From: rachelle toti <rachelletoti@gmail.com>
Sent: Tuesday, March 23, 2021 9:50 AM
To: boardclerk@slocleanair.org
Cc: Gary Willey; Karl Tupper
Subject: [EXT]Comments for the Hearing Board
Attachments: 90MoreAcres_Option1_20201022.pdf; 90MoreAcres_Option2_20201022.pdf; 90MoreAcres_Option3_20201027.pdf; 90MoreAcres_Option4_20201027.pdf

As you watch the presentations during the March 24 Update there are at least four issues that are concerning.

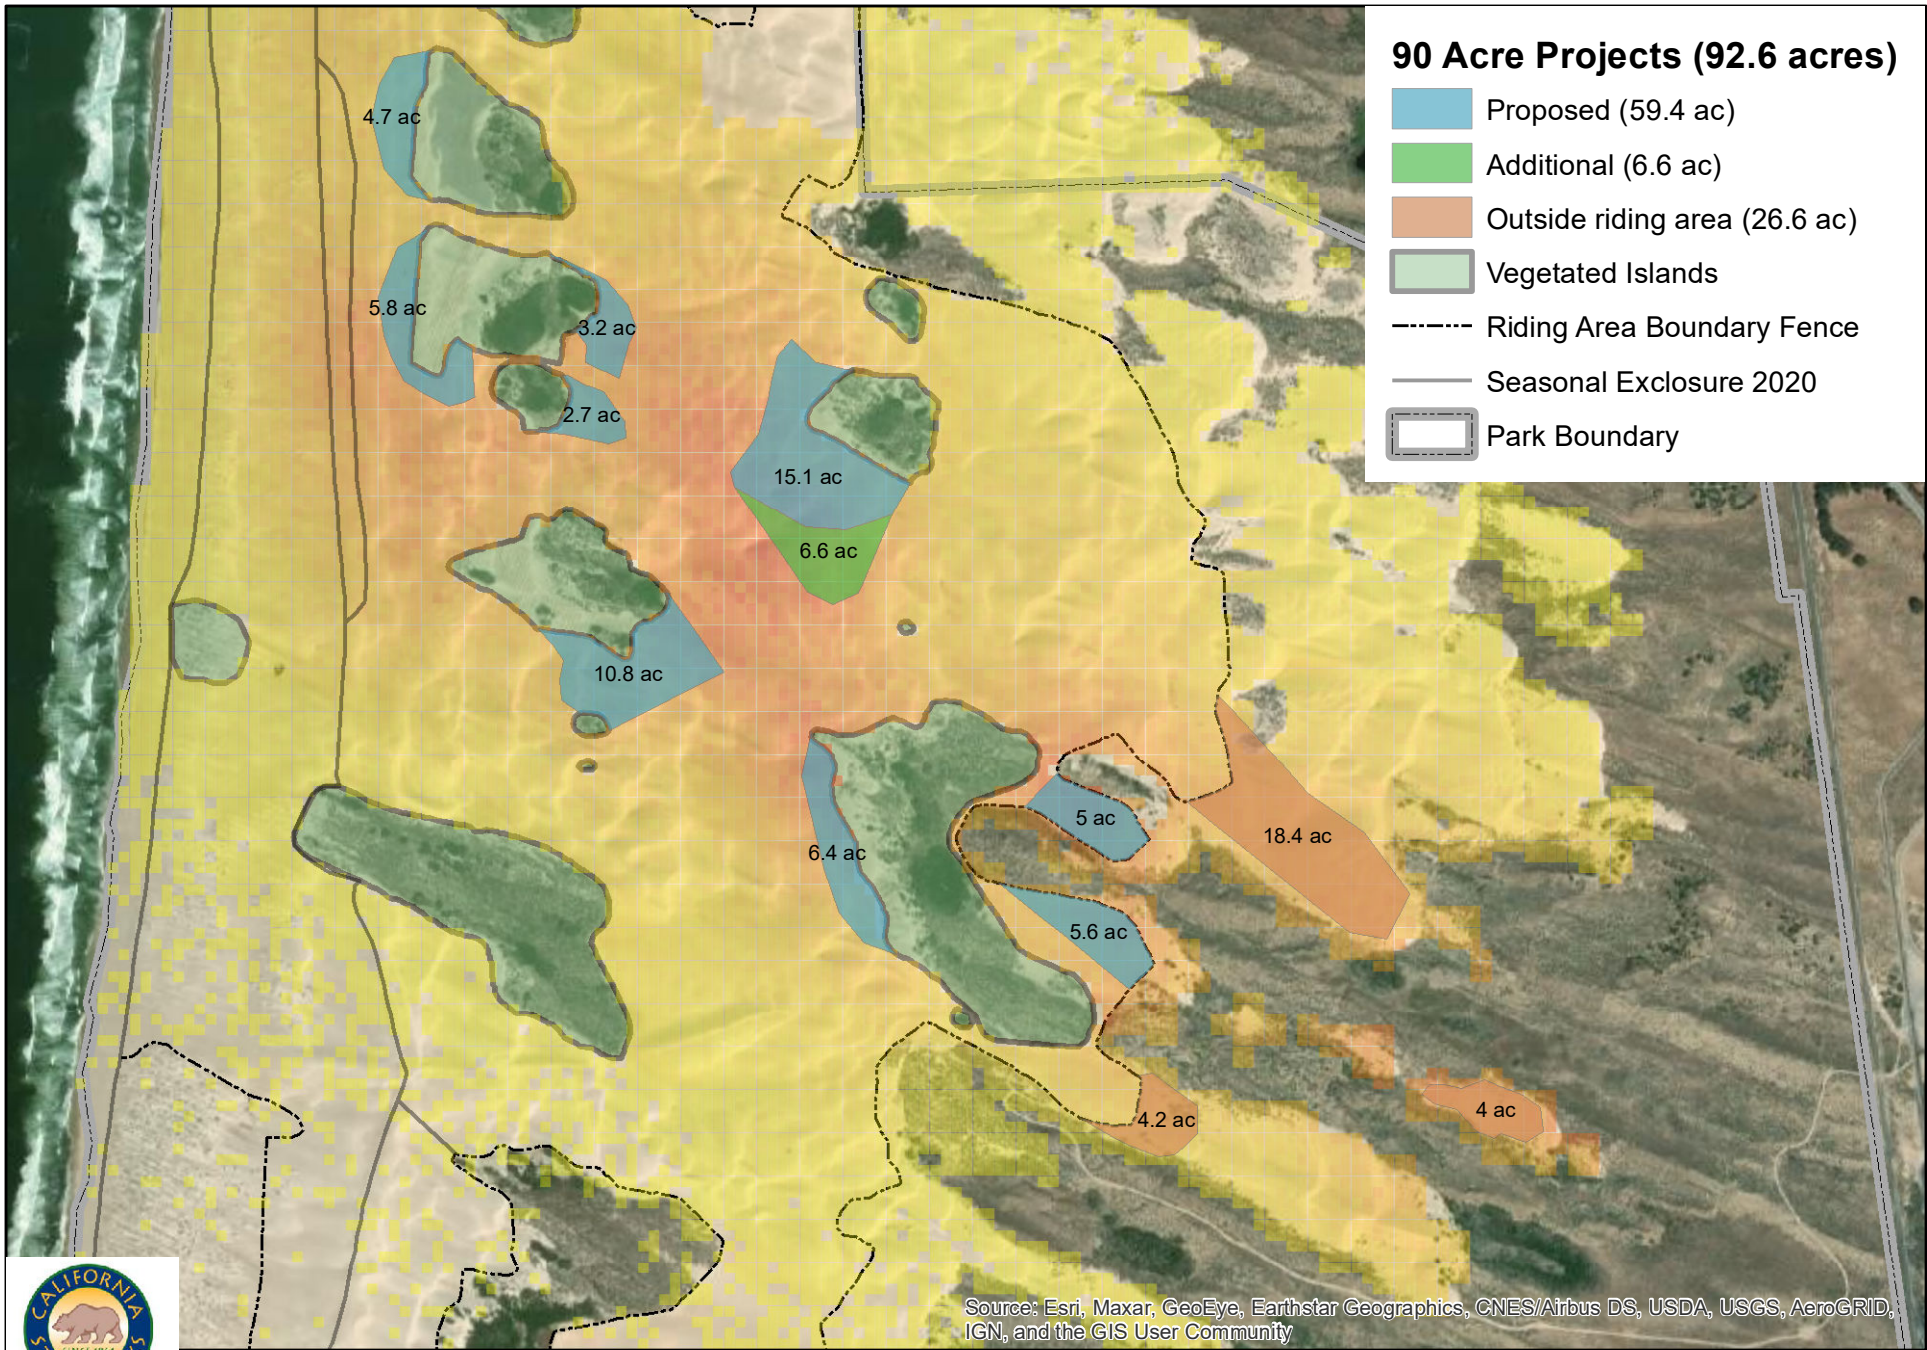
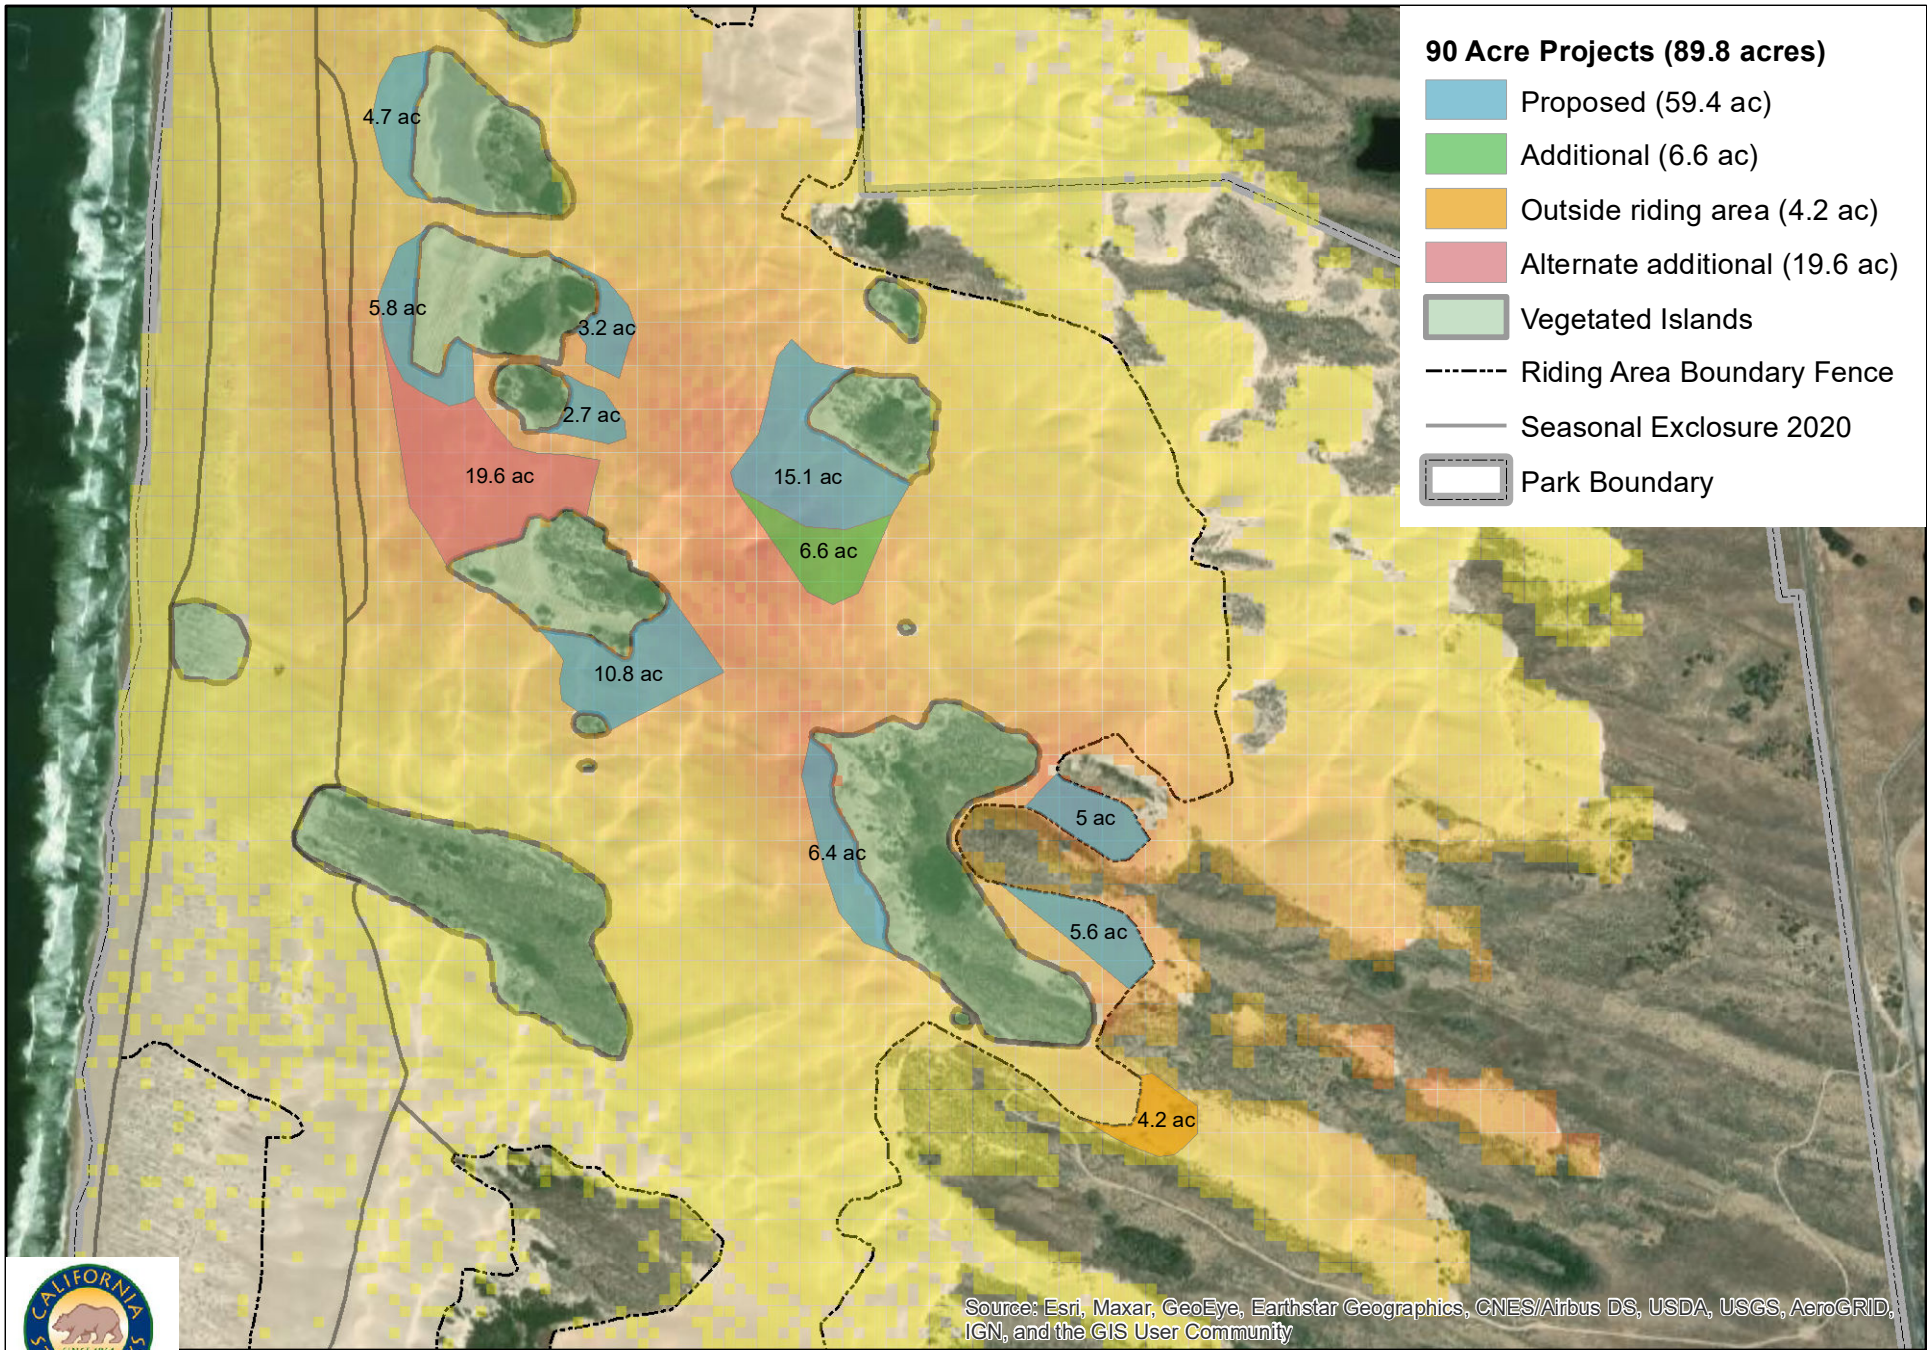
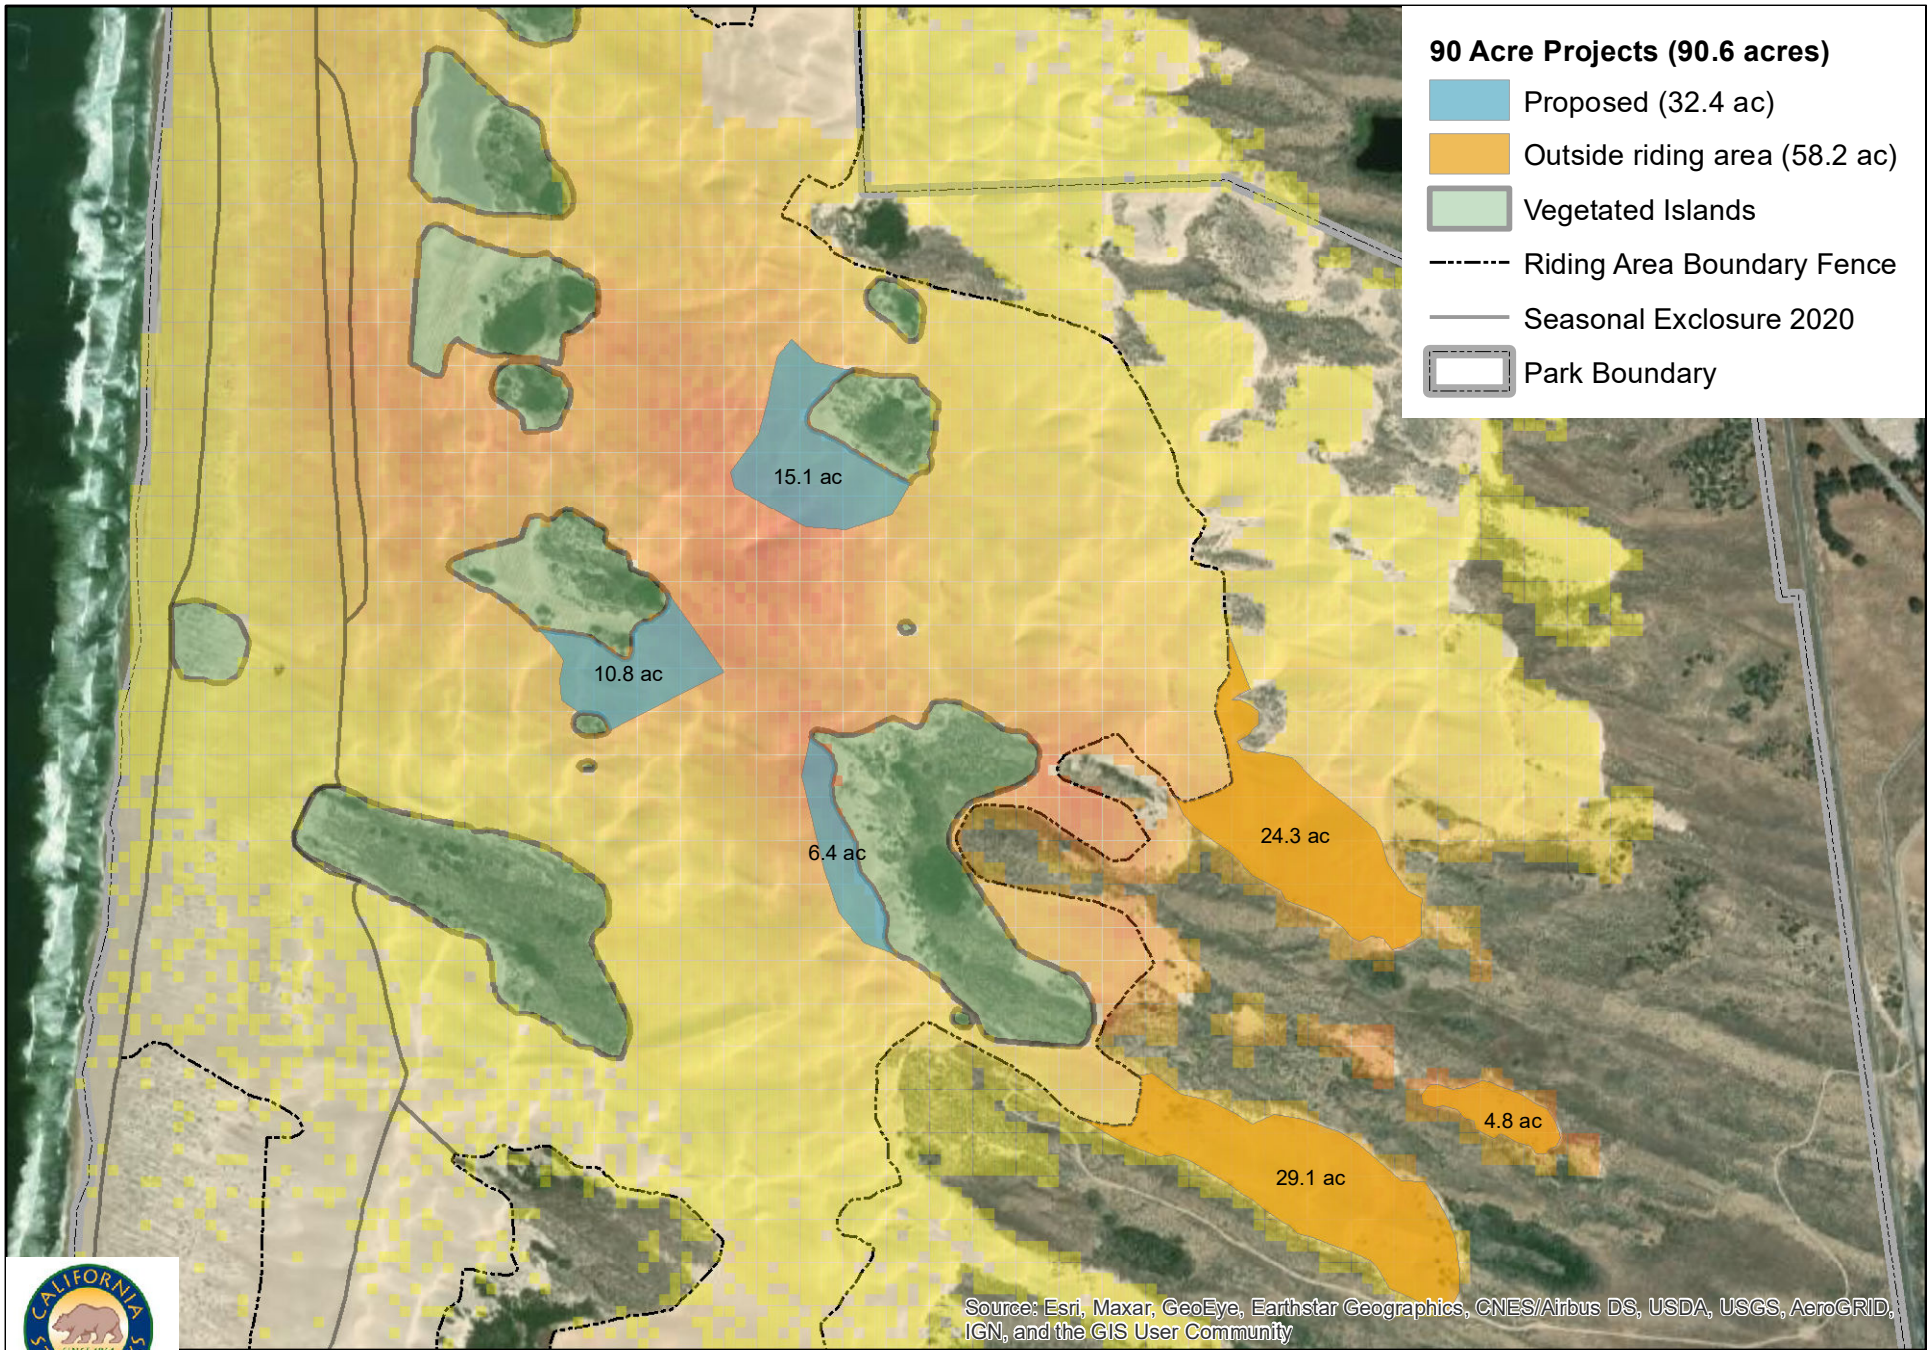
1. Timing - Why is the 2020/ 2021 dust mitigation being installed so late when it was approved in November?
2. Location - Why is 25% of this mitigation outside of the riding area?
3. Transparency -Why weren't the four options for mitigation presented to the APCO and the public in August 2020. I had to obtain them with a Public Records Act request, and then it took 2 months. See attached options.
4. Accuracy - Are the acres of mitigation being accurately counted and not double-counted. For example, 40 acres is fenced one year, awaiting native plants to be planted at a later date. When that later planting occurs in another year, or maybe 2 years, (20 acres one year and 20 acres in another year), are they being counted again as mitigation once planted.
